Appendix K:
CCPG Stakeholder Process
OCC Comments & Responses
to the CCPG
Northeast Colorado Studies

OCC Comments Regarding PSCo's June 17, 2015 Presentation Titled SWEP and Expansion Alternative Analysis

Northeast Colorado Transmission Committee
Additional Northern Greeley Alternatives Resulting from the 9/17/2015 Meeting
From the Office of Consumer Counsel after review with PUC Staff

Northern Greeley Alternatives

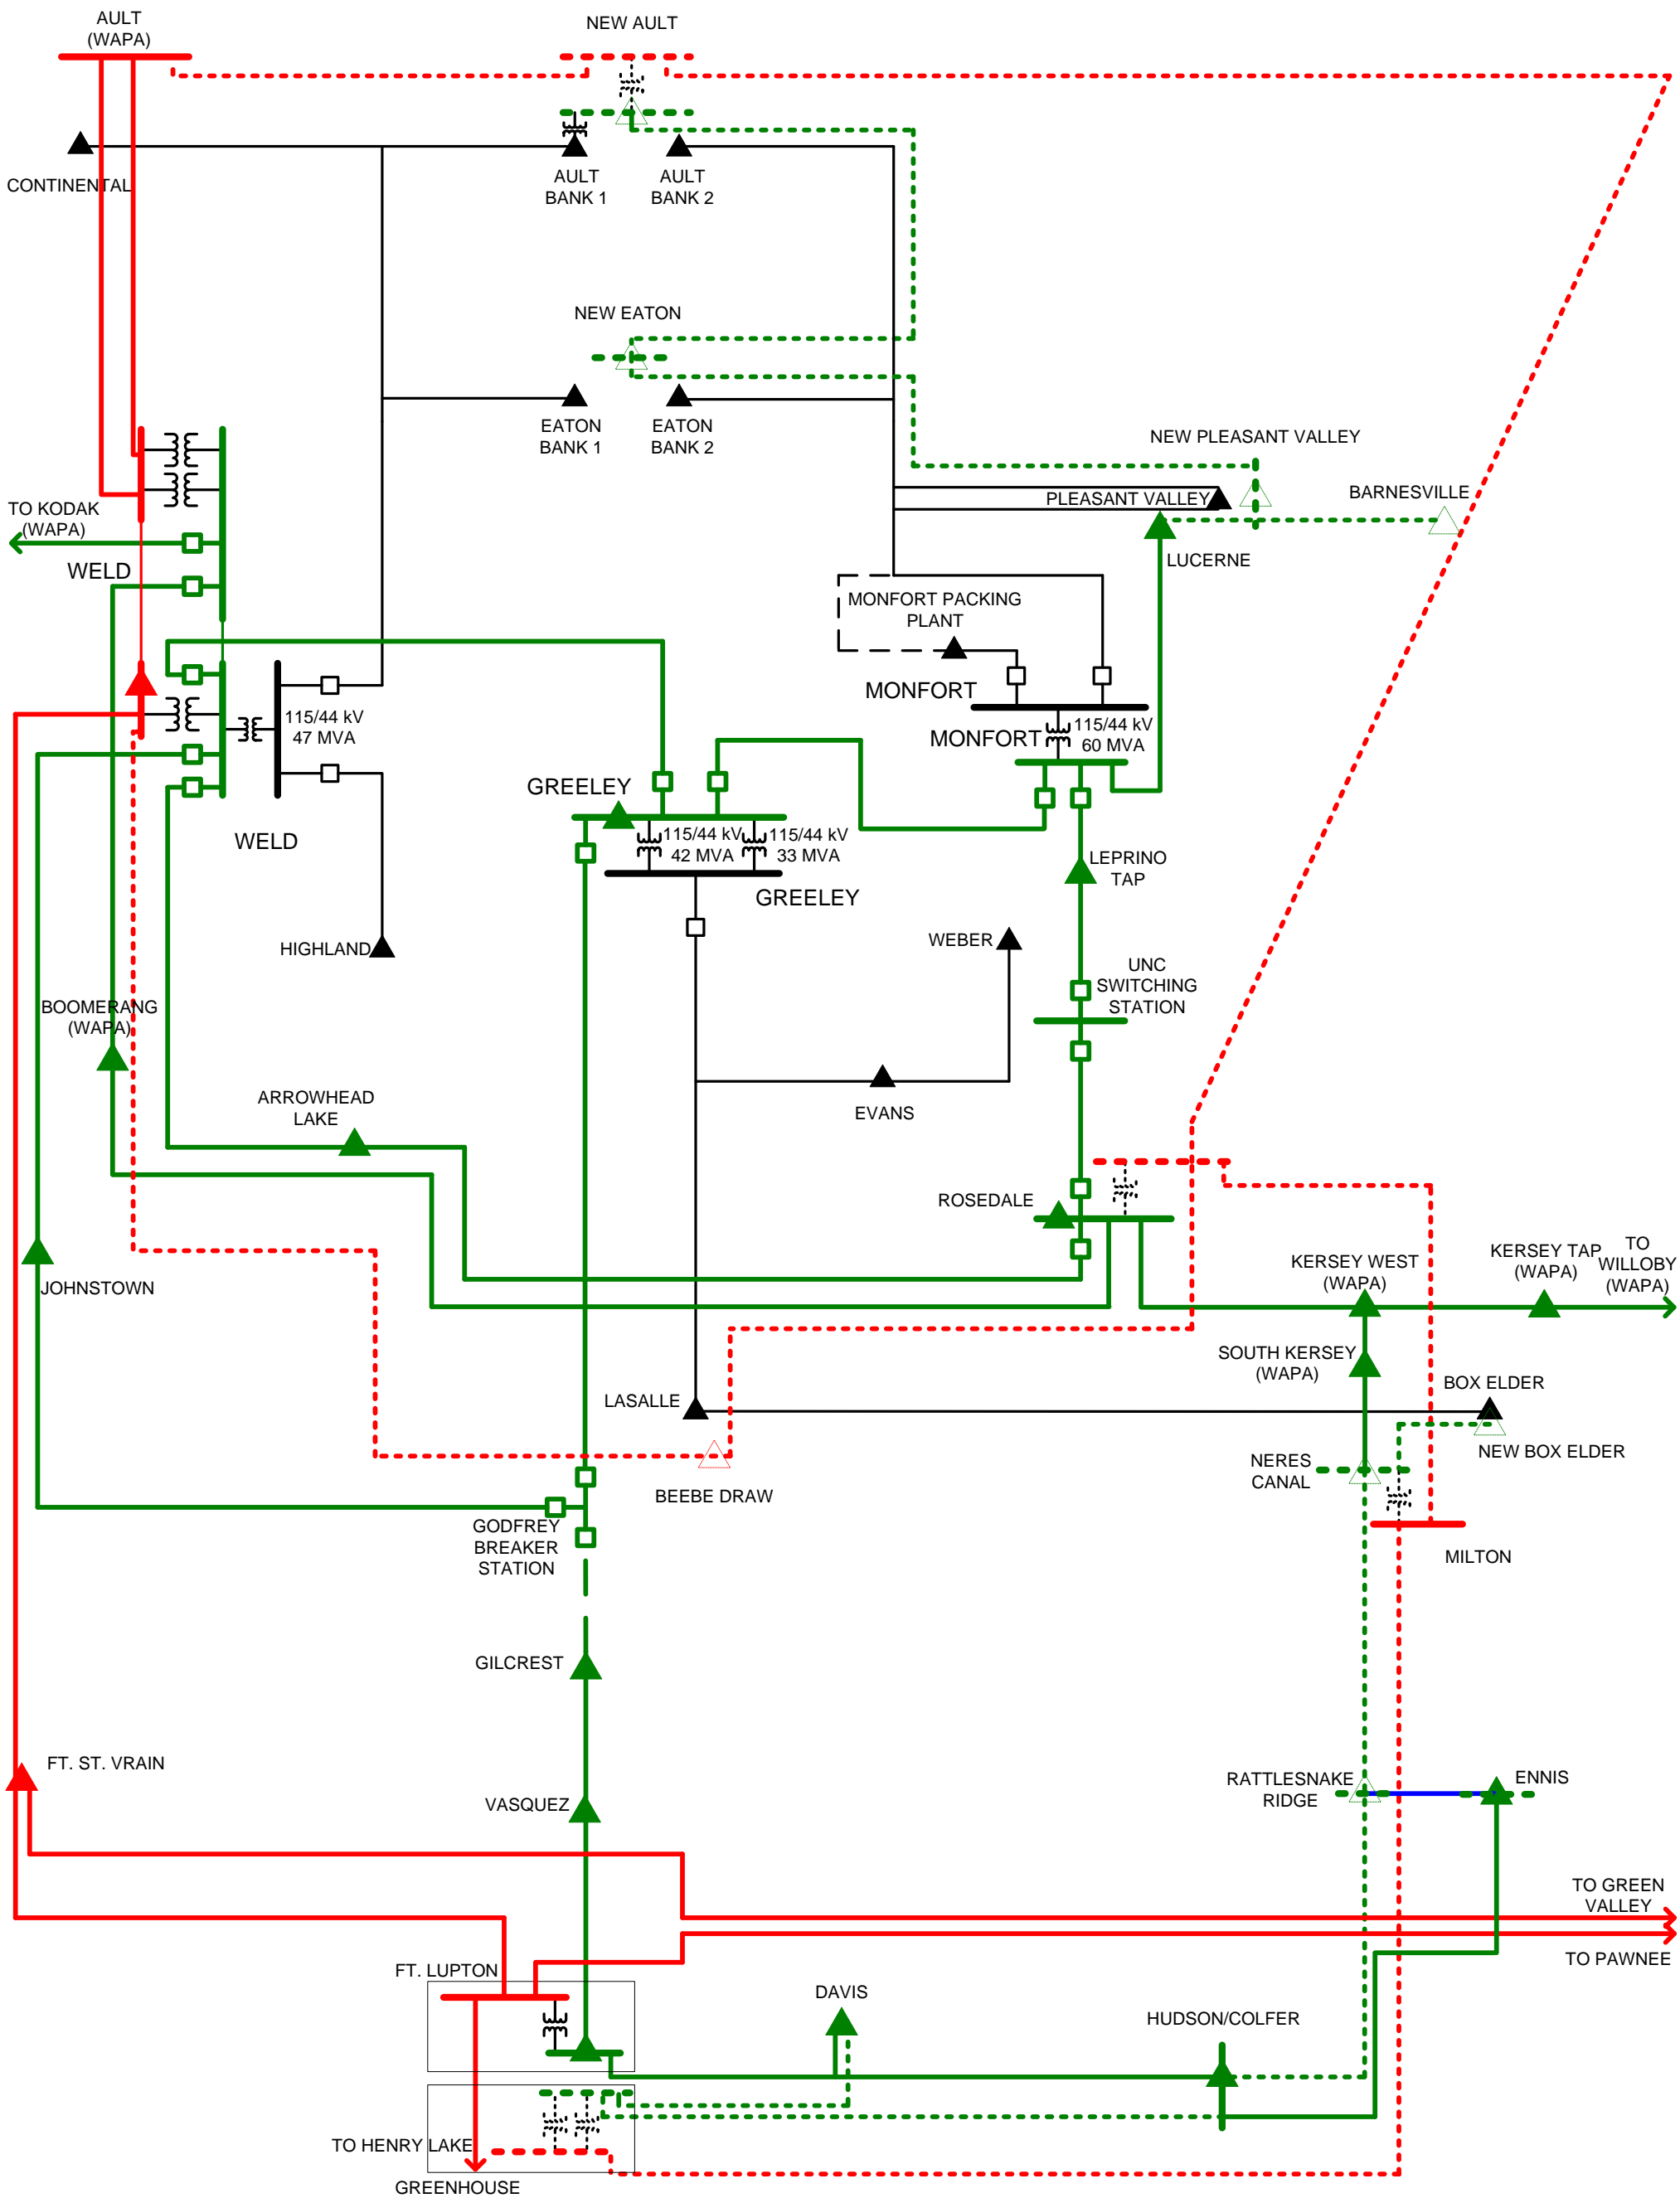
PSCo's proposed Ault-New Ault-New Eaton-New Pleasant Valley-Lucerne-Monfort ("Northern Greeley") replaces 44 kV with 115 kV and completes the 115 kV loop around Greeley from the north to east.

1. Double-Circuit 115 kV. PSCo is proposing a single-circuit 115 kV line. We suggest also studying a double-circuit 115 kV line from Ault to Monfort.
 - a. With the closure of the Godfrey to Ft. Lupton line and the addition of SWEP, a double circuit line would essentially create two new paths from Ault to Denver.

2. 230 kV Capable Line initially operated at 115 kV. PSCo is proposing a single-circuit 115 kV line from New Ault to Monfort. We suggest also studying building this line as a 230 kV capable line that would initially be operated at 115 kV.
 - a. This would involve determining whether PSCo can obtain sufficient right-of-way to upgrade from 44 kV to 230 kV from Ault to Monfort.
 - b. Eventually, the sections from Monfort to Rosedale to Kersey West and down to SWEP could also be considered for conversion to 230 kV.
 - c. This is consistent with the long-term plan that new load serving lines should be designed to be 230 kV capable.

New Neres – Box Elder – Willoby 115 kV line.	This addition would provide looped transmission service to Box Elder. This may be considered by NECO in the future depending on load development on the northern SWEP system.
Construct Ault – New Ault – New Eaton – New Pleasant Valley – Lucerne – Monfort as a double-circuit 115 kV line rather than a single-circuit line.	Replaces old 44 kV lines with new 115 kV and completes the 115 kV loop around Greeley from the north to east. Also, with the closure of the Godfrey – Ft. Lupton line and the addition of SWEP, a double circuit line would essentially create two new paths from Ault to Denver. This will be considered by the NECO Subcommittee in the future.
Construct Ault – New Ault – New Eaton – New Pleasant Valley – Lucerne – Monfort as a 230 kV line rather than a 115 kV line.	Initially operated at 115 kV. This is consistent with the long-term plan that new load serving lines should be designed to be 230 kV capable. This will be considered the NECO Subcommittee in the future.

ALTERNATIVE ROUTES

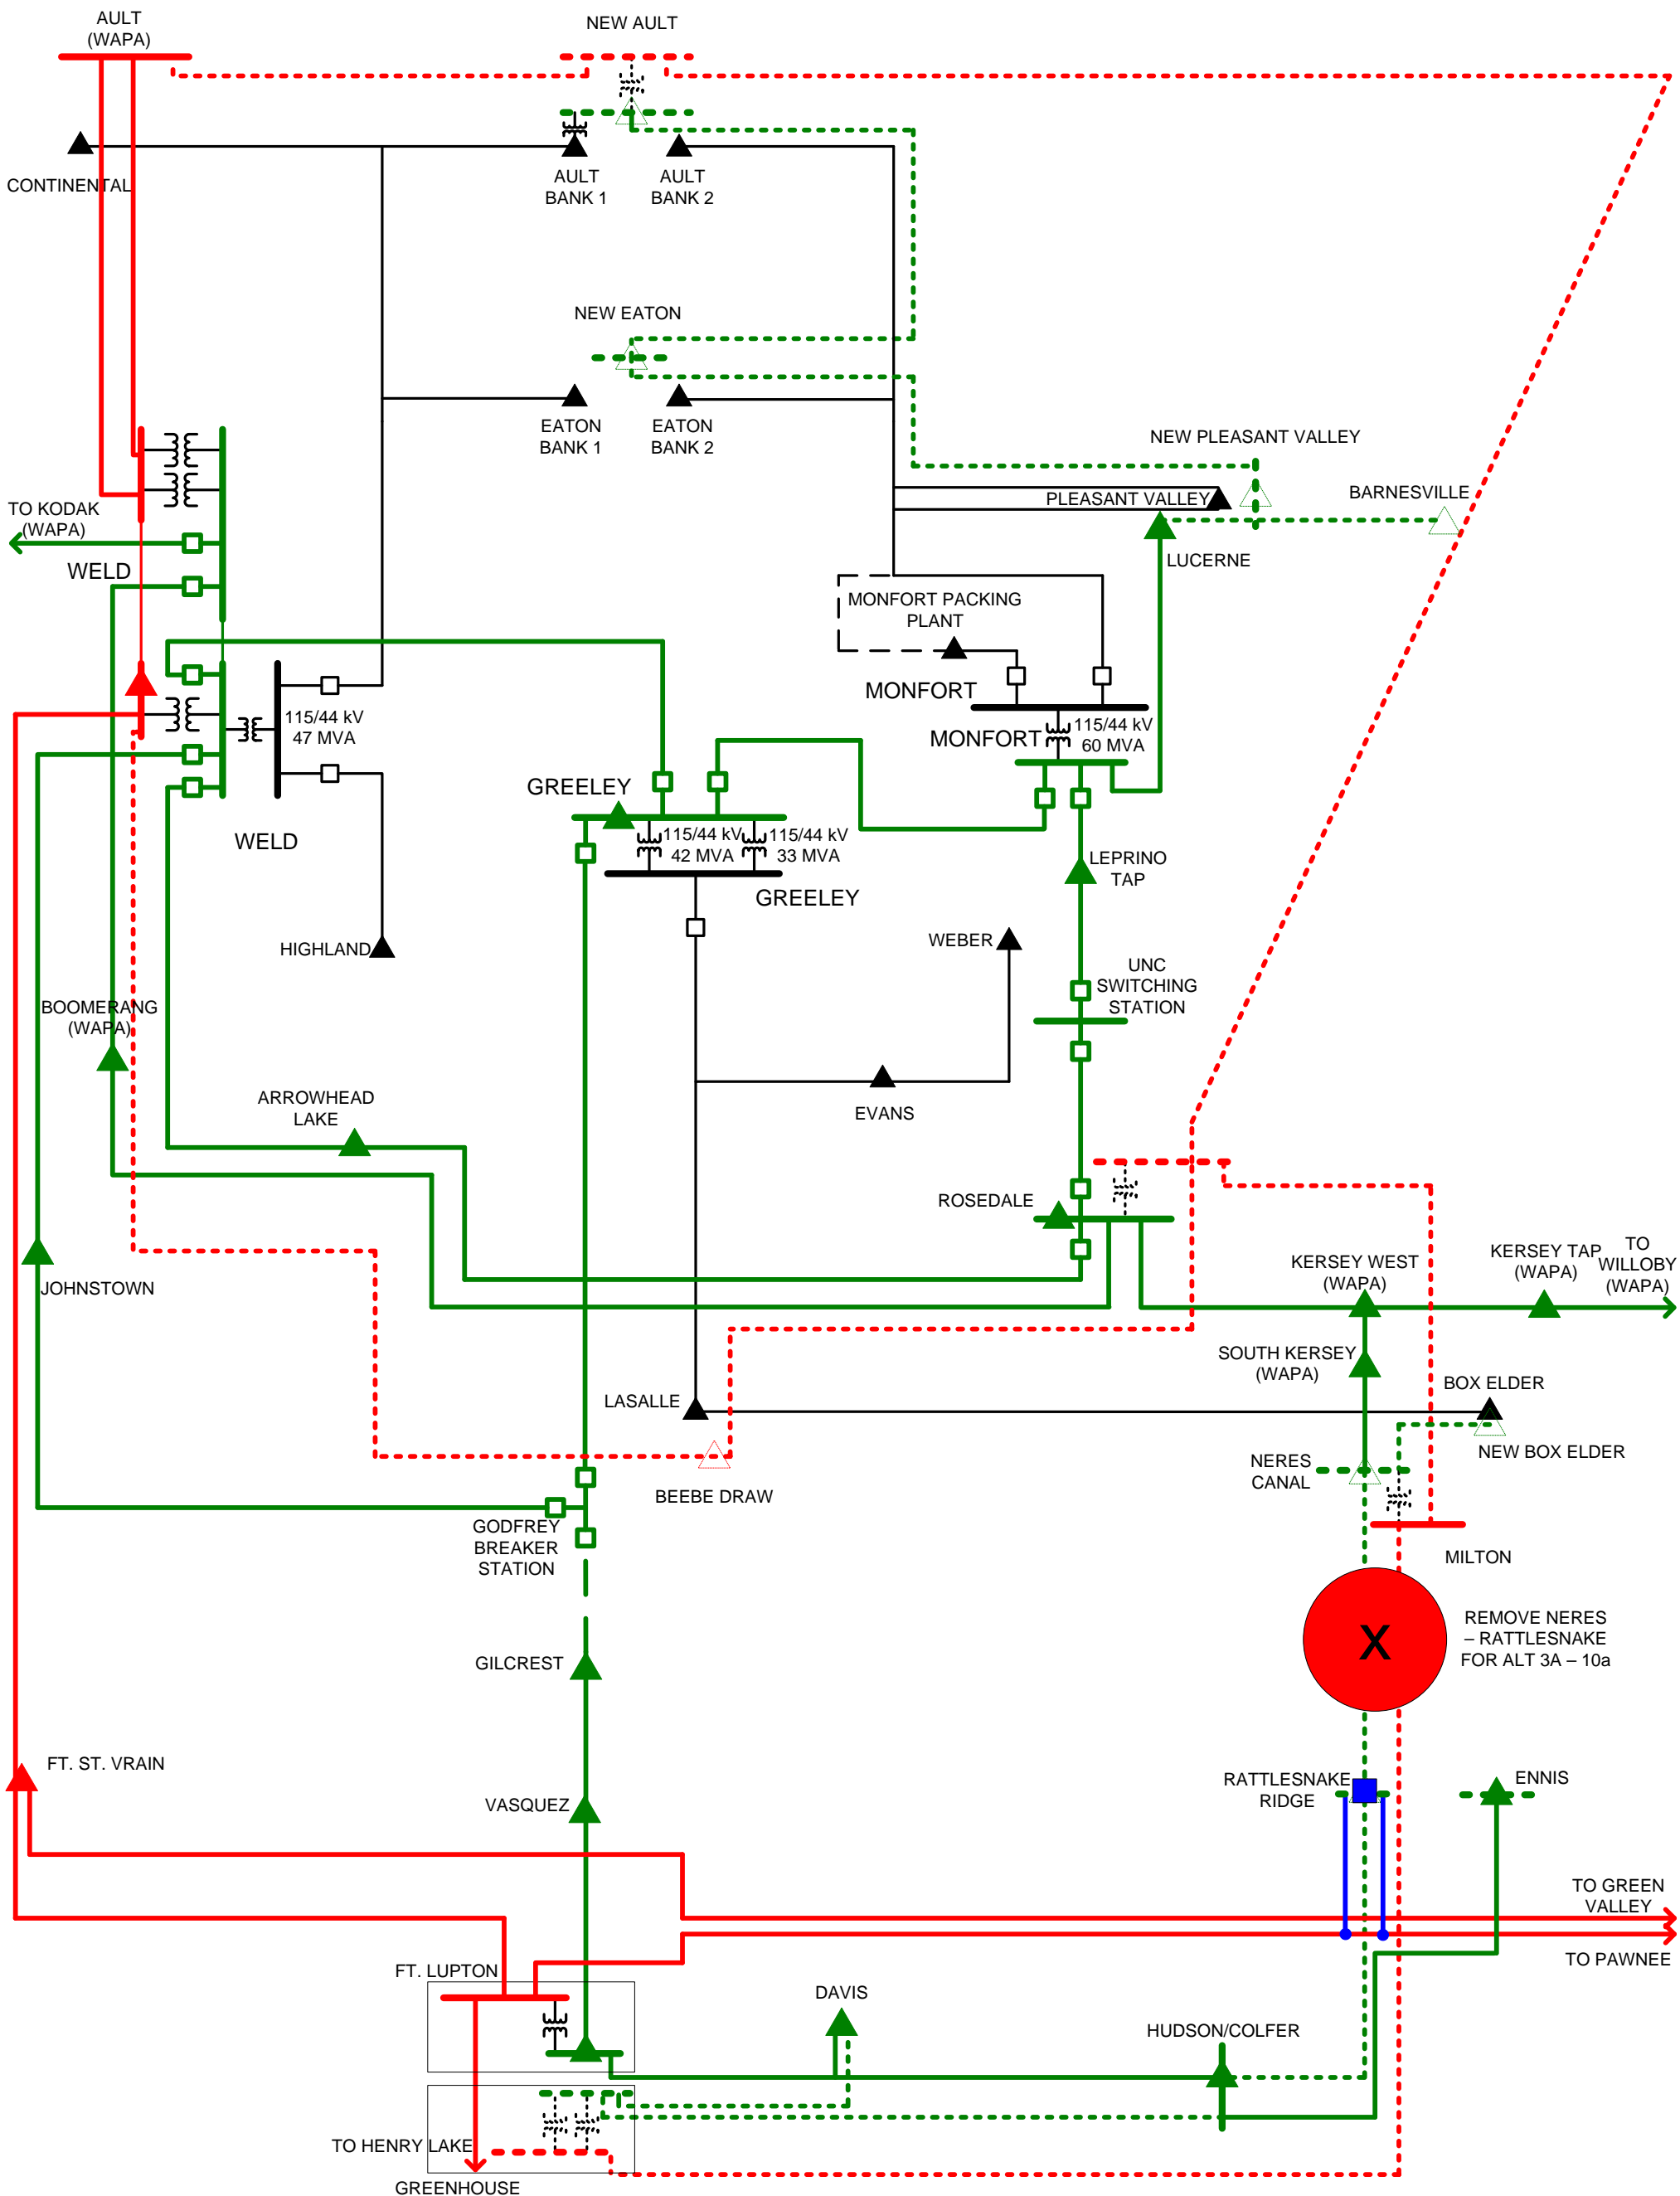
X
 REMOVE NERES - RATTLESNAKE FOR ALT 3A - 10a
